**ISSUE:** Certificate of Appropriateness for new construction

**LOCATION:** Parker-Gray District  
1417 Princess Street

**BAR #2019-00528**  
**1417 Princess Street**

## **I. APPLICANT'S PROPOSAL**

Figure 3: proposed west elevation of 1417 Princess

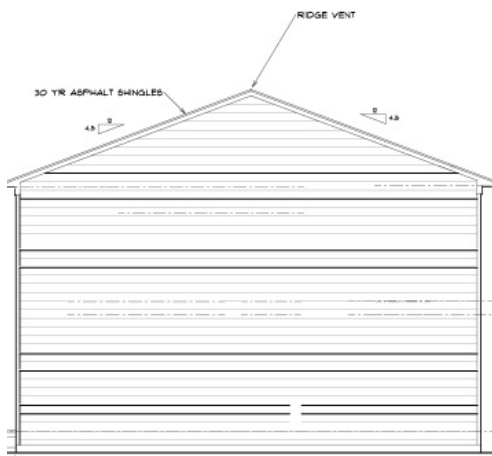
In staff's opinion, the proposed single-family dwelling is consistent with the broader recommendations contained in the *Design Guidelines* for new construction (figure 1). The proposed new construction reflects historic development patterns found throughout Alexandria. There is a clear pattern of two-story, two-bay, side gable roof, single-family vernacular structures throughout the historic districts, including the 300 block of North Patrick Street (figure 2), the 800 Block of Oronoco Street and the 1100 block of Queen. Although the proposed 4.5:12 roof slope is slightly less than the traditional 6:12 for a 19<sup>th</sup> century house with wood shingles, the roof slope will be minimally visible once other houses are constructed on the adjacent lots.

FRONT ELEVATION (SOUTH)  
SCALE: 1/4" = 1'-0"

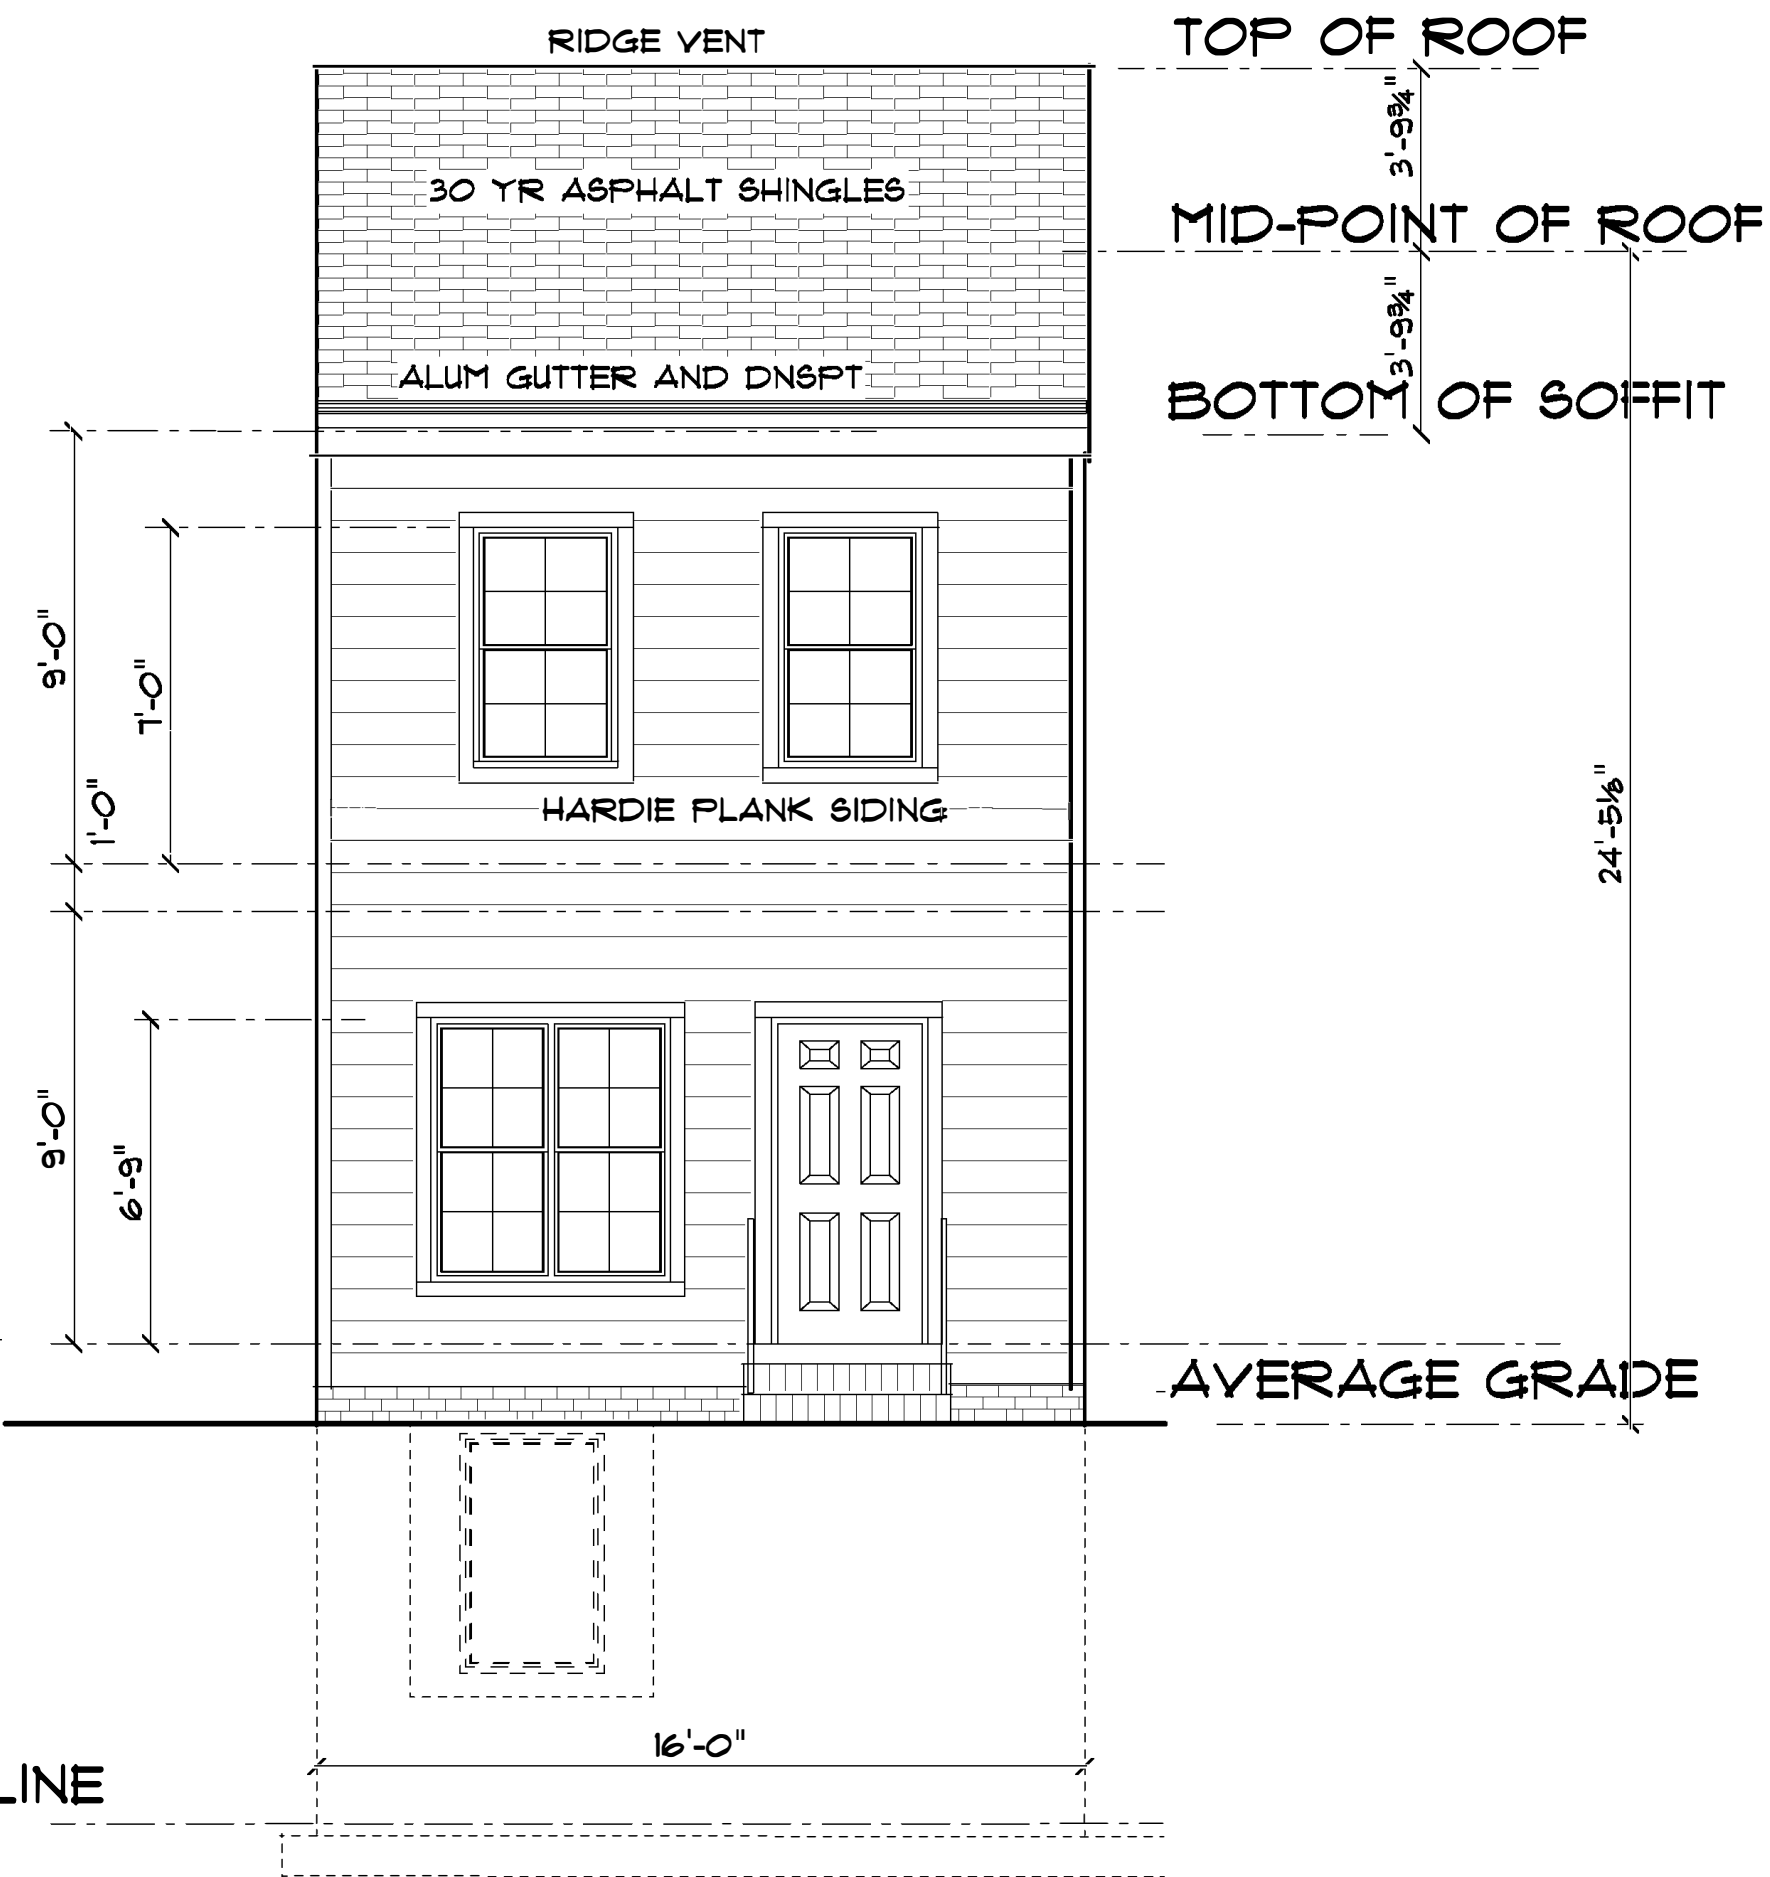
1. Fiber cement lap siding must have a smooth finish, per BAR policy;
2. Install a three-light transom above the entrance door on the south facade.
3. Install 6/6 double -hung windows on the second floor, in lieu of 4/4 sash, on the south facade.

4. Install a 9/6 window on the first floor of the south facade, matching the size of the window panes of the second floor windows and with the head to align with the head of the transom above the entrance door.

5. All proposed street facing windows must be aluminum clad wood or fiberglass SDL in compliance with the *Alexandria New and Replacement Window Performance Specifications in the Historic Districts*. Windows on other facades may be of any material, without tinted or reflective glass;

The submitted plans include an egress window well located below-grade on the street facing elevation with the top covered by a grate. By practice, the BAR does not review window wells if there is no guardrail, and no guardrail is proposed here. The applicant must submit the design and operation of the window well grate with the building permit application, so that they may ensure egress compliance.
